ADA Evaluation

City of Hudson, New York

prepared by
Hyman Hayes Associates

February 16, 2021

Photo Reference [F](#)

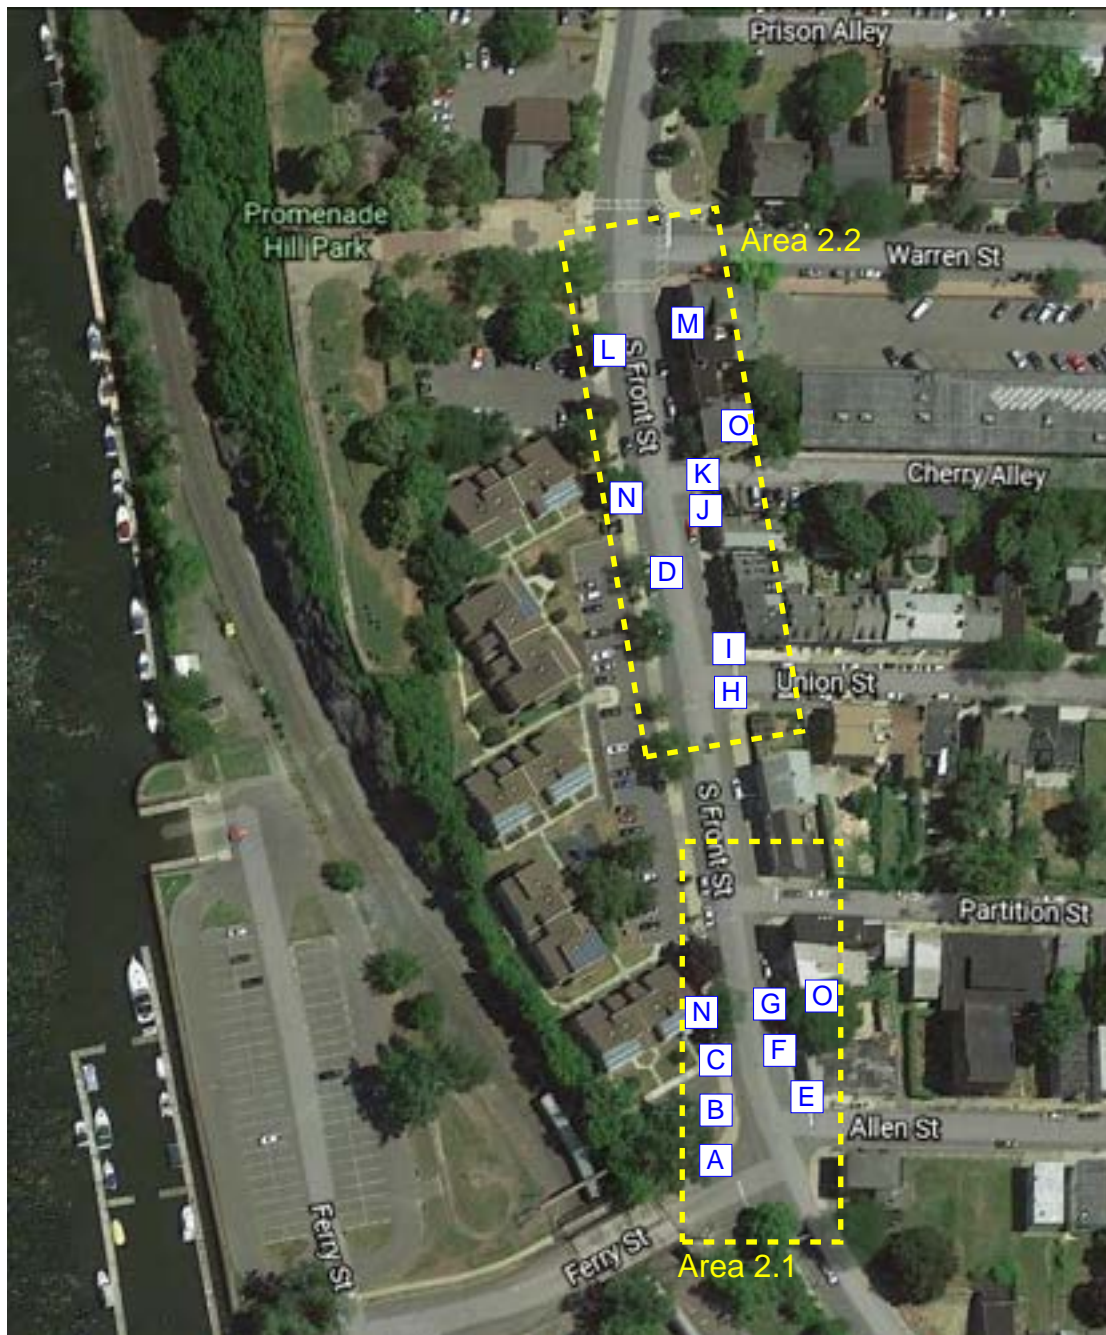
Area 1 - Henry Hudson Riverfront Park to Ferry Street Bridge				
Photo Ref.	Location	Item	ADA Ref.	Comments
A	Broad St and Water St park entrance	Accessible Parking and sidewalk access	\$208 \$402.2	The Broad Street parking lot and street parking along Water St. provides parking for access to the Hudson Riverfront Park, however, no accessible parking is at either location for park access.
B	Sidewalk along Water St.	Greater than 1/4" level change at ground surface	\$303	Level change at joint between concrete walk sections
C	Sidewalk along Water St.	Opening in ground surface greater than 1/2"	\$302.3	Opening at joint between concrete walk sections
D	Sidewalk along Water St.	Opening in ground surface greater than 1/2"	\$302.3	Opening at joint between concrete walk sections
E	Sidewalk along Water St. near Water St. park entrance	Greater than 1/4" level change at ground surface	\$303	Level change between pavement and concrete walk is greater than 1/4"

Photo Reference [KK](#)

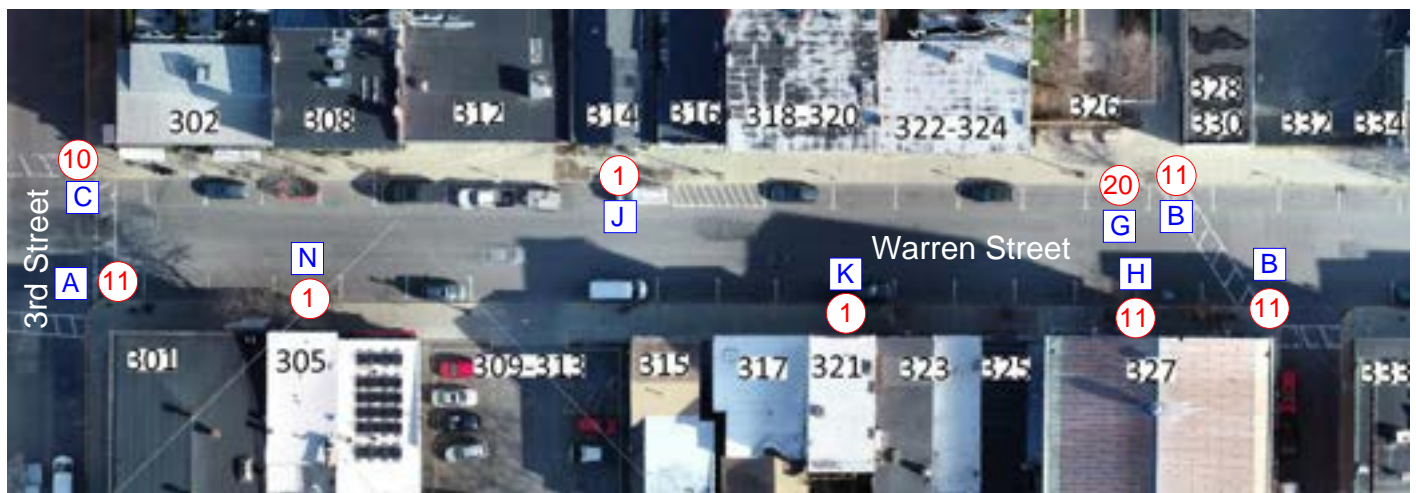
KK	Sidewalk at 259 Warren St.	Greater than 1/4" level change at ground surface	§303	Utility cap at sidewalk extends above sidewalk more than 1/4"

Photo Reference [S](#)

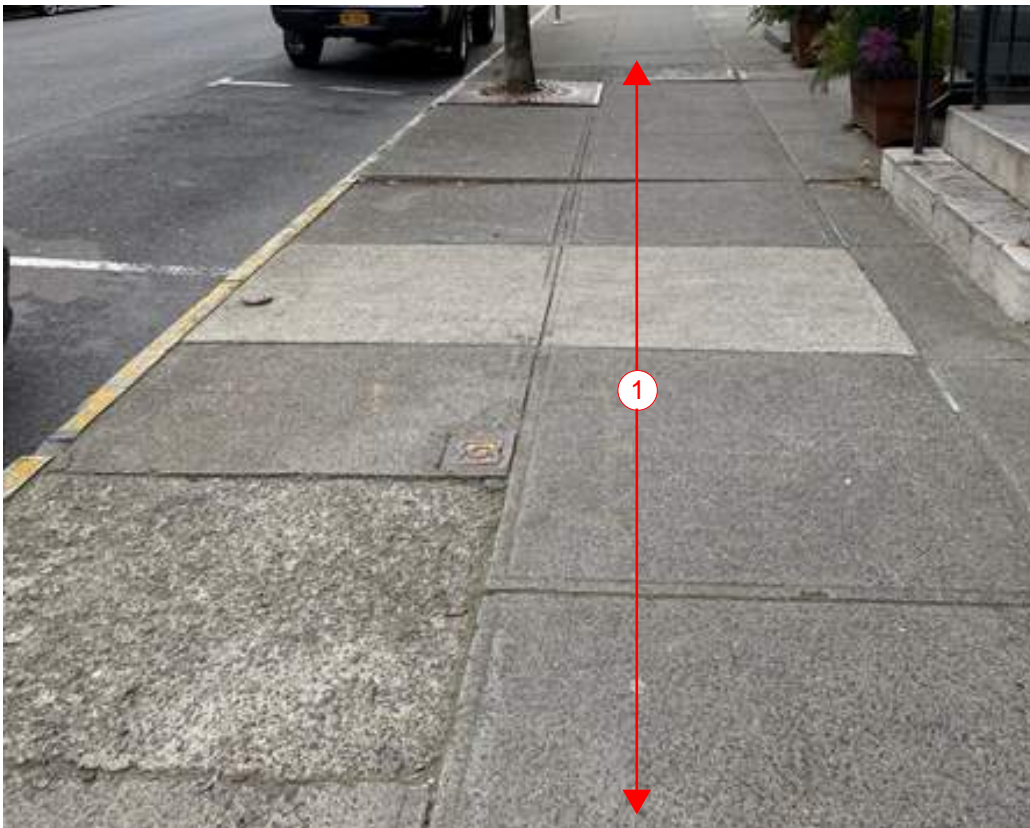
S	Sidewalk from 339 to 345 Warren St.	Greater than 1/4" level change at ground surface	\$303	Multiple instances of unlevel sidewalk sections along route indicated.
T	Sidewalk along 351- Warren St.	Ground surface cross slope greater than 2.0%	\$403.3	Section of walk along route has a cross slope of 9%.
U	NW corner of Warren and 4th St.	Greater than 1/4" level change at ground surface	\$303	Utility cover is recessed below walk with a level change greater than 1/4"
V	Sidewalk at 406 Warren St.	Greater than 1/4" level change at ground surface	\$303	Sections of concrete walk is uneven with level changes greater than 1/4".
W	Curb ramp at SW corner of 4th and Warren	Curb ramp flares greater than 10%	\$406.3	The slope of the left flared edge on the curb ramp along 4th St. is 11%. The max. slope for flared sides is 10%.

Photo Reference M

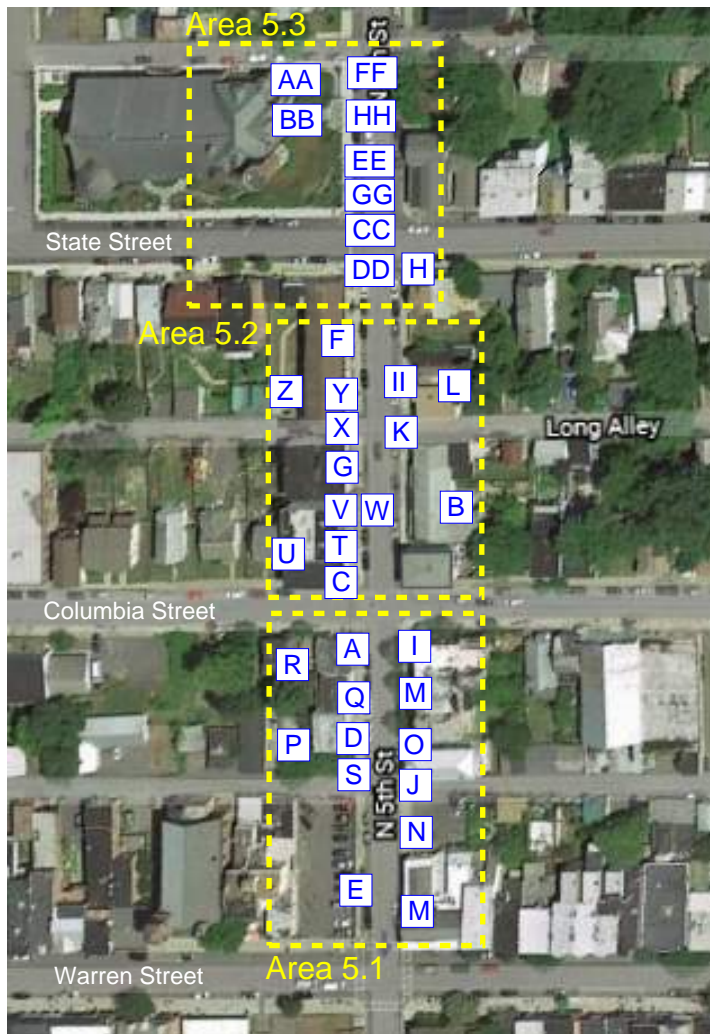
Area 4 -3rd and Warren to 18 S. 3rd St. (including access to Youth Center)				
Photo Ref.	Location	Item	ADA Ref.	Comments
M	Sections of concrete sidewalk along 3rd St. from Warren St. to Union St.	Greater than 1/4" level change at ground surface	§303	The concrete walk along 3rd street are damaged and unlevel causing consistent level changes greater than 1/4" along the extend indicated.

1 - Greater than $\frac{1}{4}$ " level change at ground surface.
General photo of consistent occurrence along extend indicated
